S.I.L. NO. 06-560-01

SERVICE INFORMATION LETTER

SUBJECT: Torque Transducer Filter

Applicability: JetProp #1 to JetProp #176.

DRAWING TITLE: ACCESSORIES, CONTROLS & EQUIPMENT INSTALL					
SHEET 2 OF 7					
DRAWING NUMBER: 560.07.200					
REV R

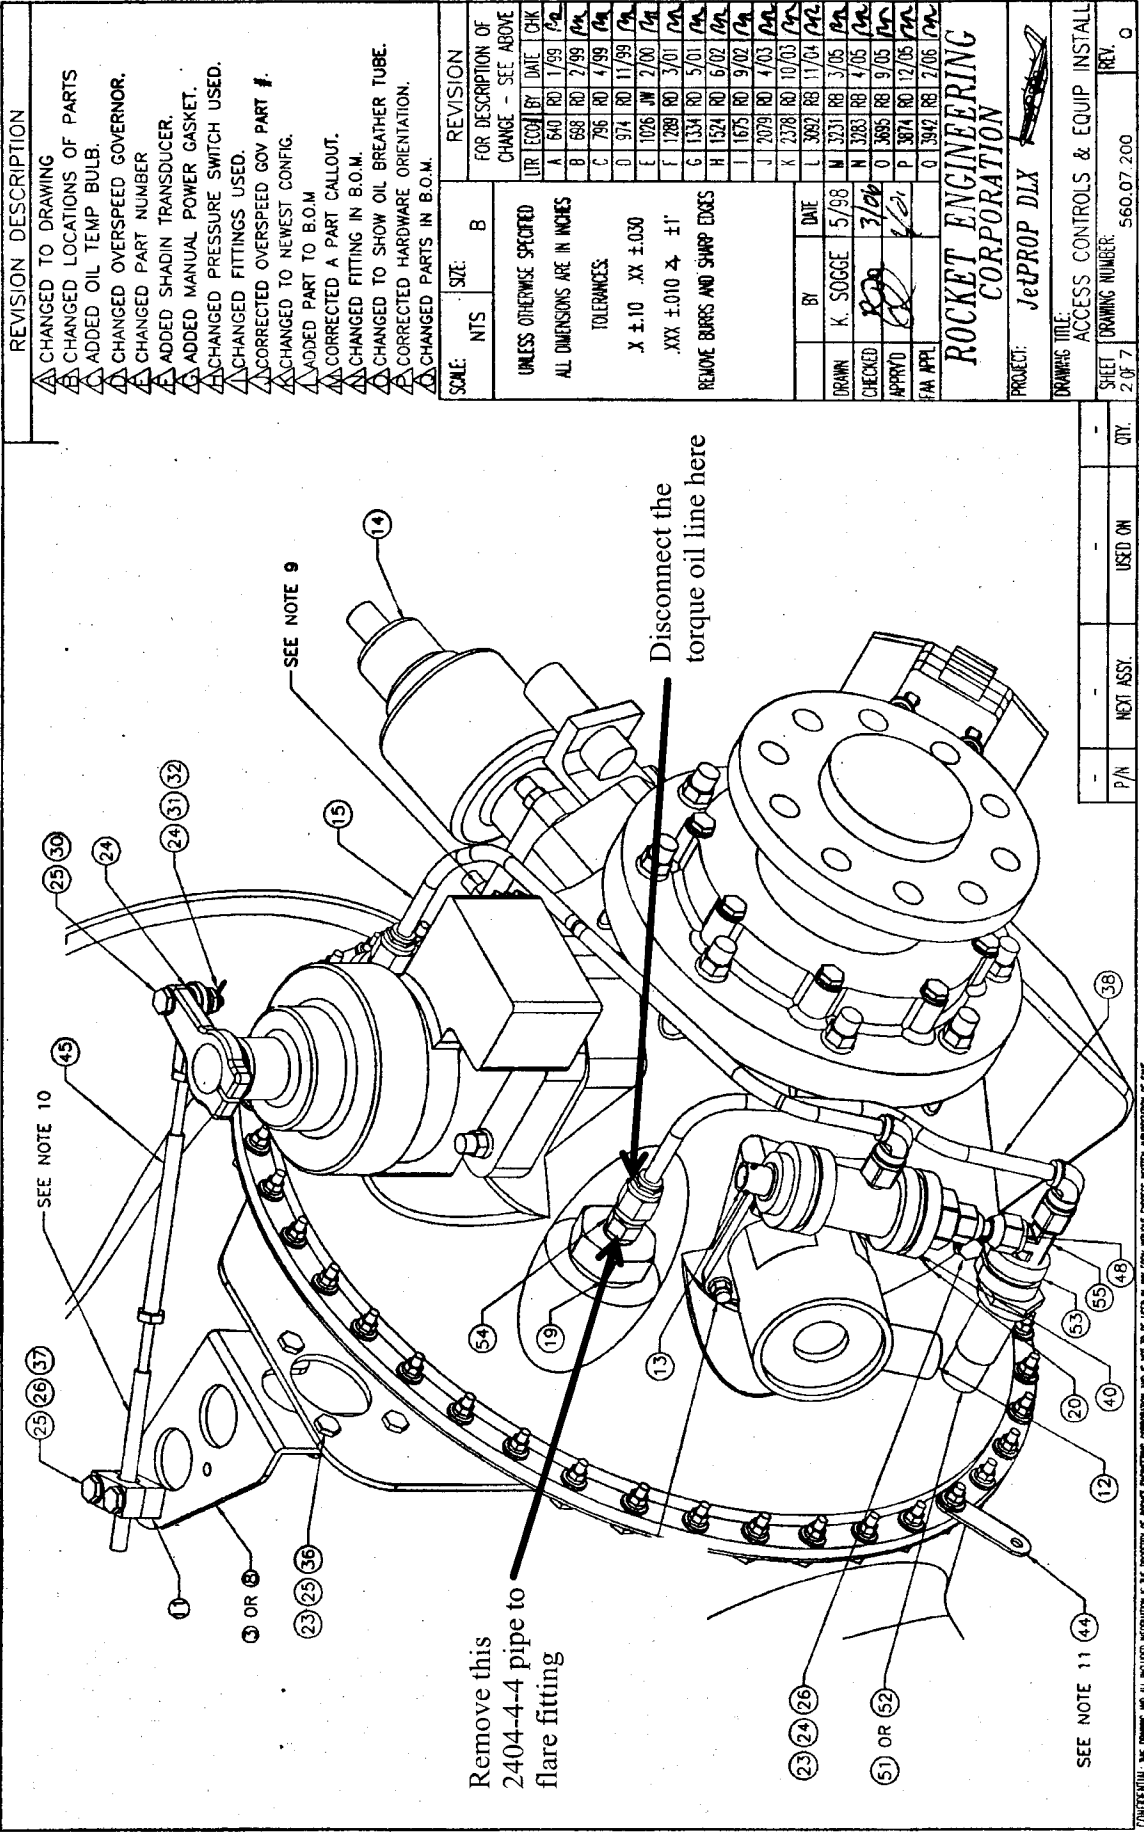
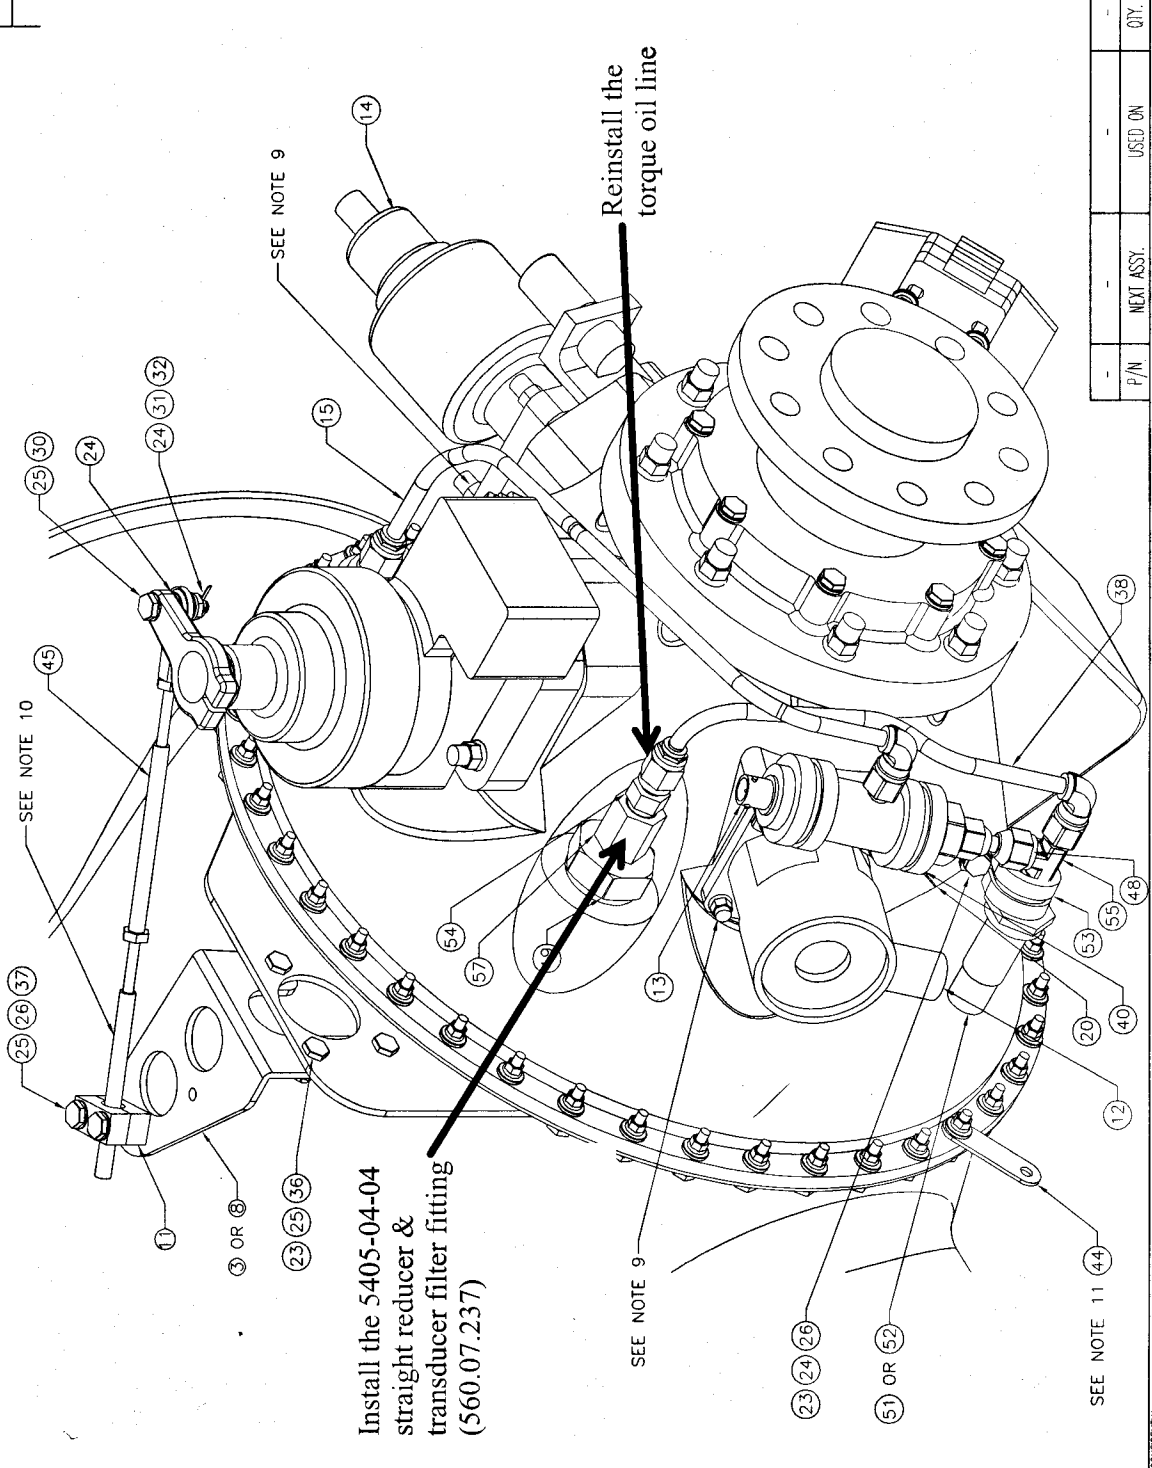
A few JetProps have experienced torque indicating problems found to be caused by contaminants in the torque transducer. To help prevent this problem JetProp LLC has developed a filter designed to filter out contaminants in the oil just prior to the torque transducer. This new filter can be easily installed as discussed below.

1. Remove the top cowling.
2. On the front right side of the engine locate the torque transducer and the oil line running to bottom of the torque transducer. Disconnect the oil line at the engine as shown in Drawing 560.07.200 Rev Q.

3. Remove the 2404-4-4 pipe to flare fitting from the large fitting installed in the engine. (See Drawing 560.07.200 Rev Q.)
4. Replace the fitting removed in step 3 above with a straight reducer 5405-04-04 and the Transducer Filter Fitting (560.07.237). See Drawing 560.07.200 Rev R.

5. Reconnect the oil line disconnected in step 2 above to the Transducer Filter Fitting installed in step 4. See Drawing 560.07.200 Rev R.
6. Perform a ground run of the engine to verify there are no oil leaks and that the torque transducer functions properly.
